FED. ROAD DIST. NO.	STATE	FED. AID PROJ. NO.	FISCAL YEAR	SHEET NO.	TOTAL SHEETS
HAWAII	HAW.	I-H3-I(61)	1990	281	424

HALAWA APPROACH

HAIKU APPROACH

DATE	REVISION
8/6/92	REVISED DOMESTIC WATER GPM AND SANITARY GPM & TANK SIZE PER DCN61-031
4/26/90	DELETED NOTE: 25 GPM FROM CONTROL BUILDING
STATE OF HAWAII DEPARTMENT OF TRANSPORTATION HIGHWAYS DIVISION WATER BALANCE DIAGRAM STANDARDS INTERSTATE ROUTE H-3 F.A.I. PROJ. NO. I-H3-I(61)	
SCALE: NONE	DATE: JAN 1990
SHEET NO. M2	OF 8 SHEETS

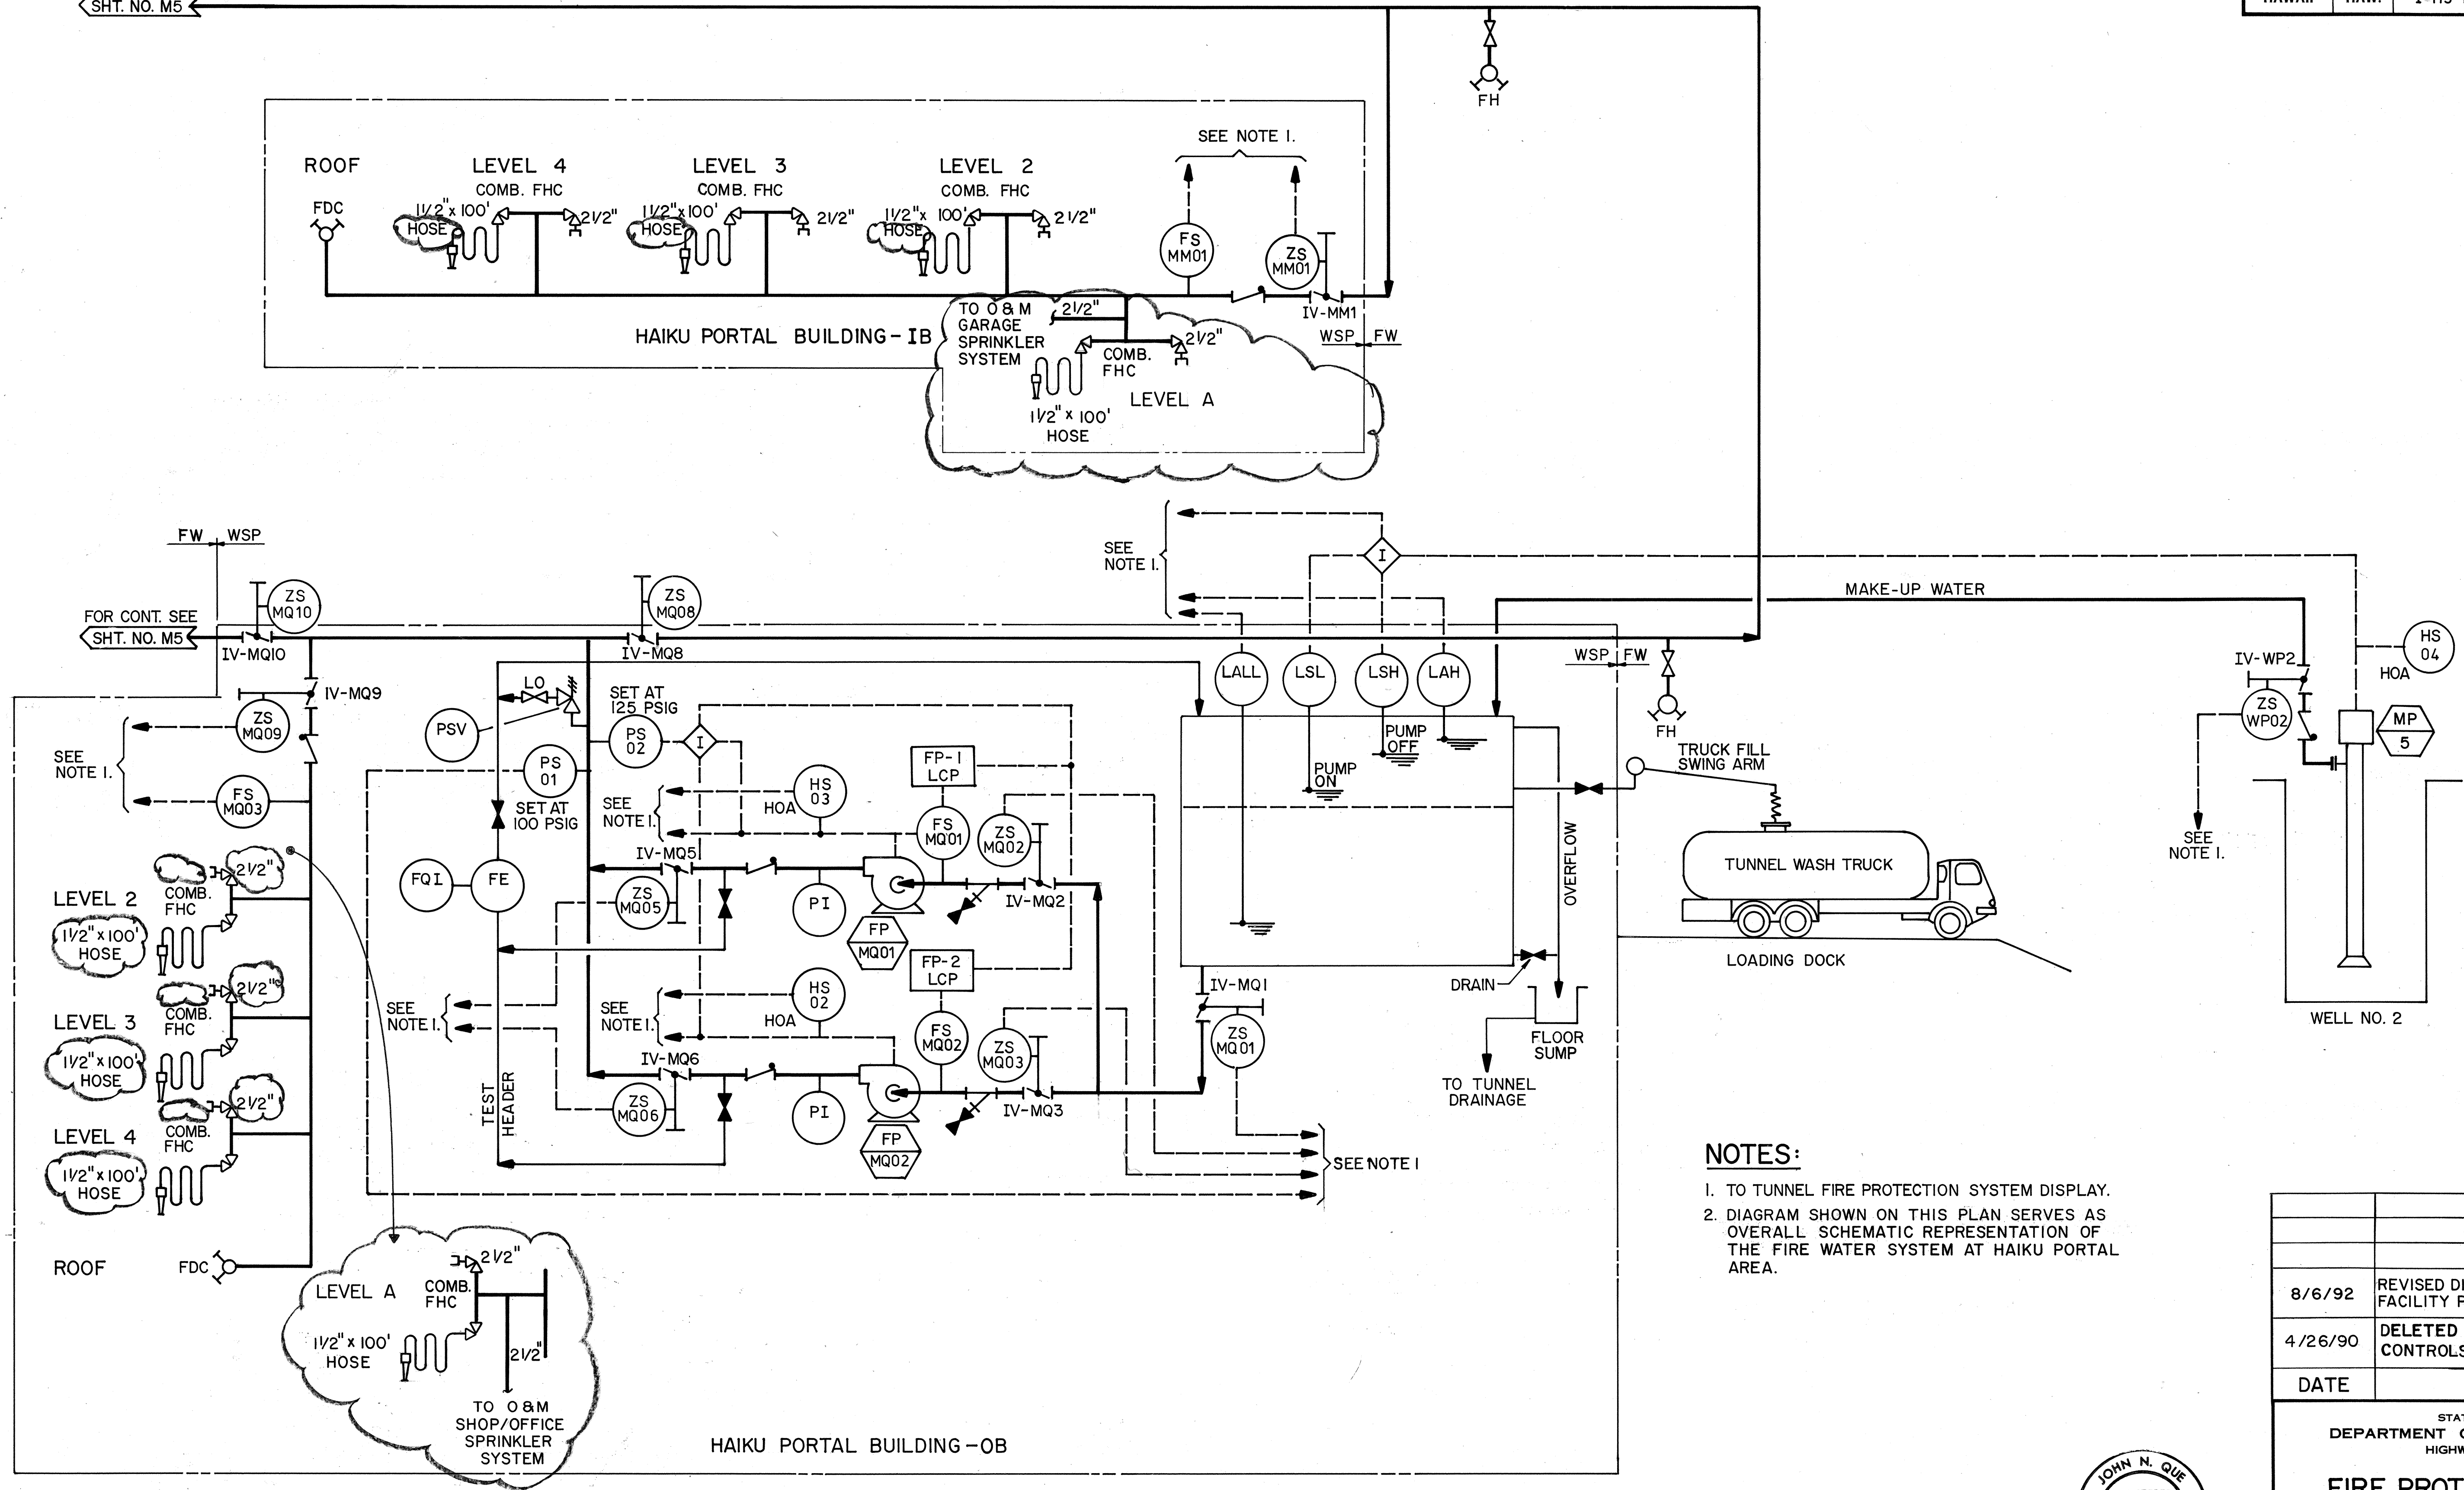
DATE	REVISION
8/6/92	REVISED DIAGRAM TO SHOW O & M FACILITY PER DCN 61-031
4/26/90	DELETED JOCKEY PUMP PIPING & CONTROLS
STATE OF HAWAII DEPARTMENT OF TRANSPORTATION HIGHWAYS DIVISION FIRE PROTECTION-P&ID-1 STANDARDS INTERSTATE ROUTE H-3 F.A.I. PROJ. NO. I-H3-1(61) SCALE: NONE DATE: JAN 1990	
SHEET NO. M4 OF 8 SHEETS

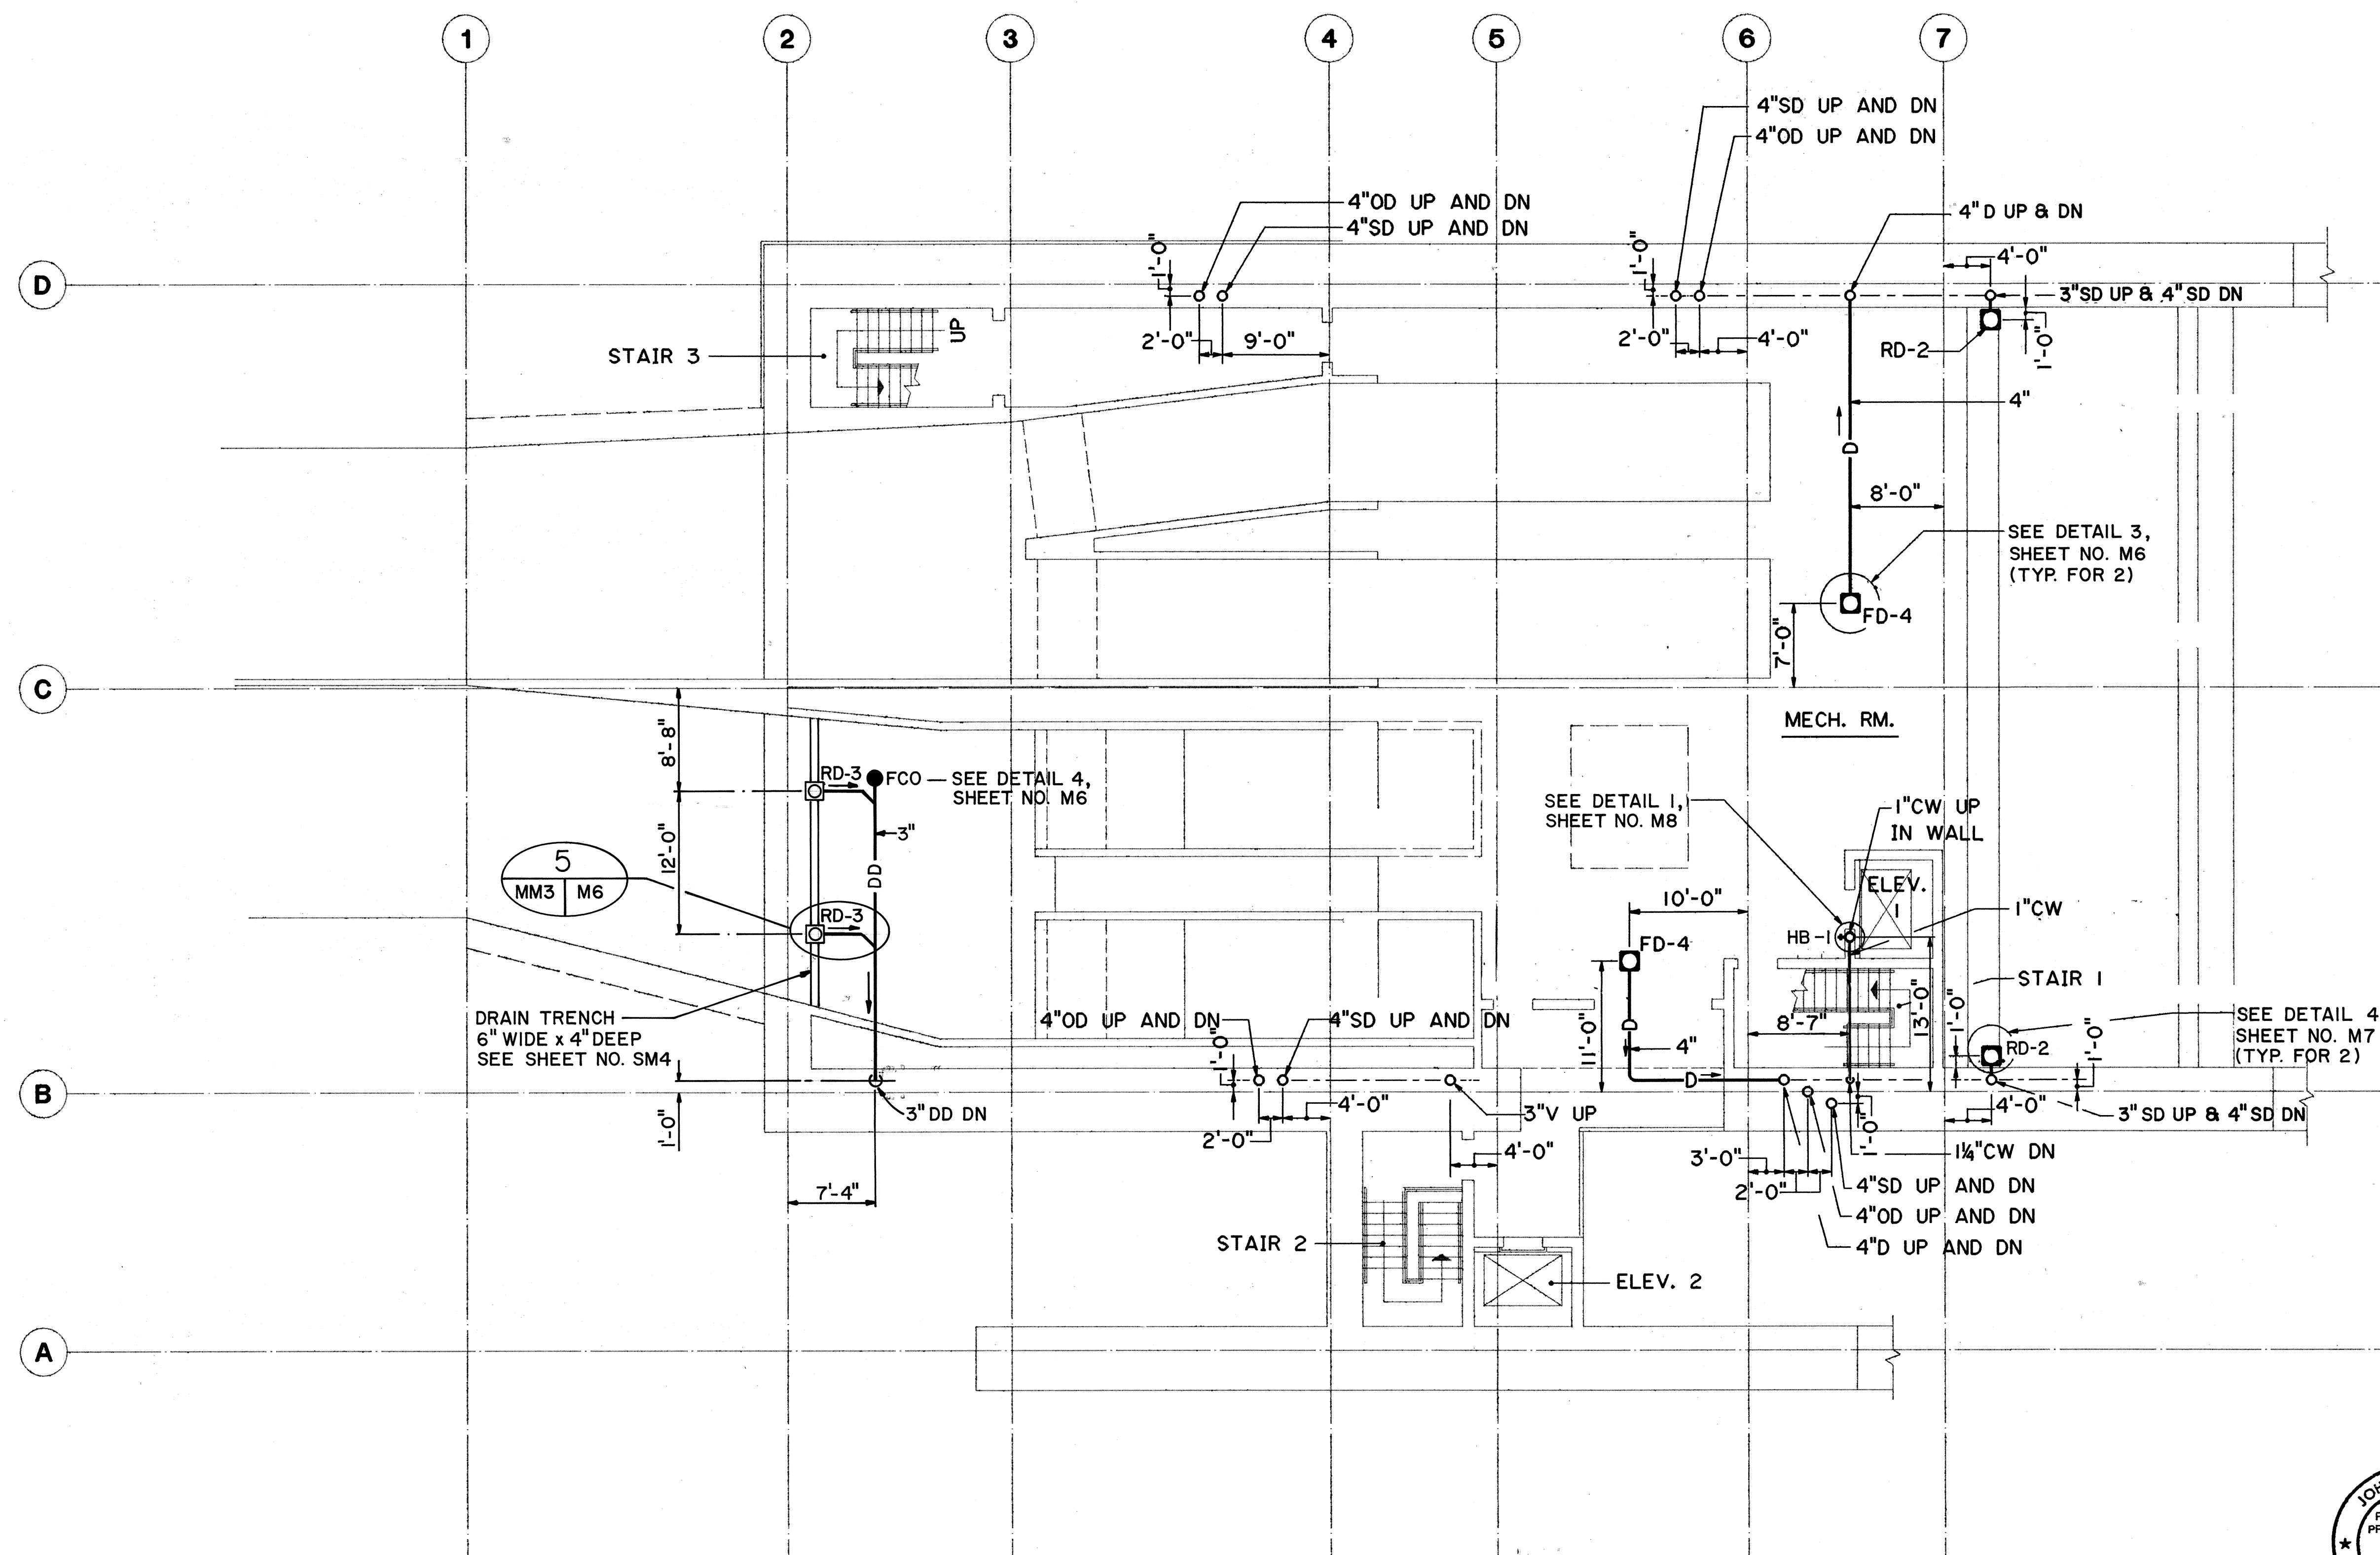
MAR 19, 1990	ADDENDUM 1 - CHANGED 4" SD TO 3" SD UP & 4" SD DN
DATE	REVISION
STATE OF HAWAII DEPARTMENT OF TRANSPORTATION HIGHWAYS DIVISION PLUMBING - LEVEL 2 PLAN HAIKU PORTAL BUILDING - 1B INTERSTATE ROUTE H-3 F.A.I. PROJ. NO. I-H3-1(61)	
SCALE: 1/8" = 1'-0"	DATE: JAN 1990
SHEET NO. MM3	OF 9 SHEETS

**PLUMBING -
ROOF LEVEL**

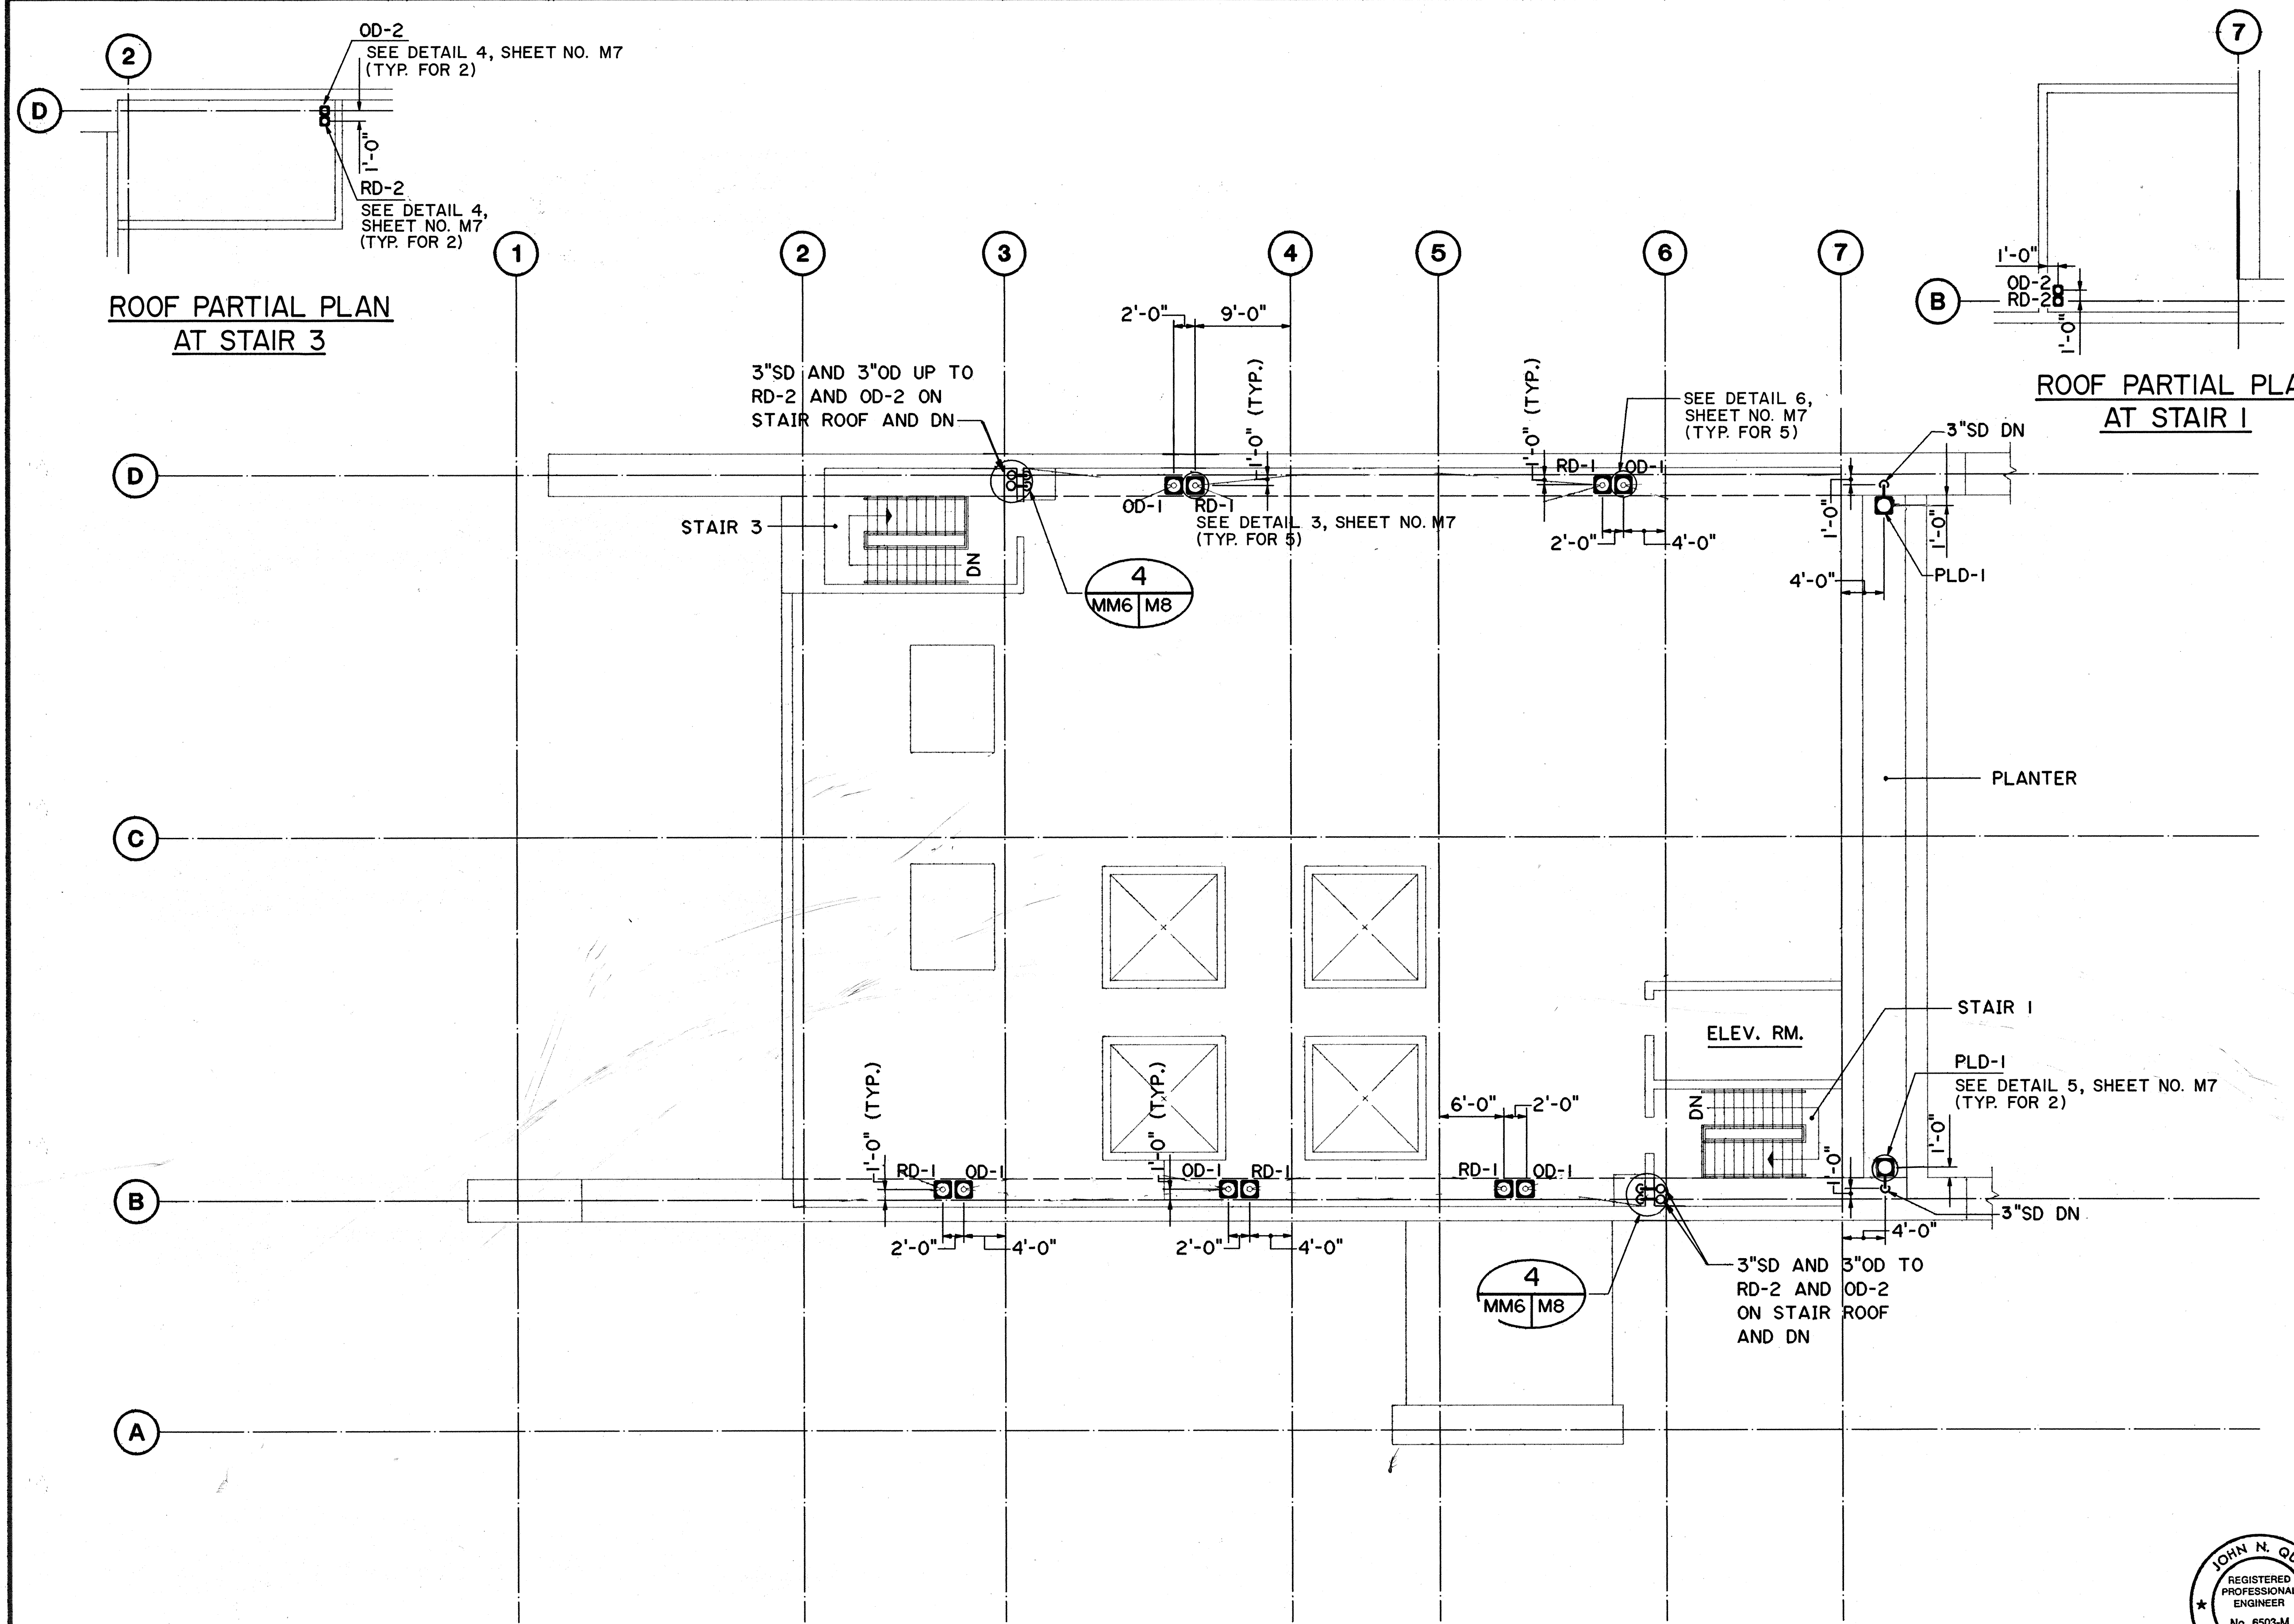
MAR 19, 1990		ADDENDUM I-CHANGED 4"SD TO 3"SD	
DATE		REVISION
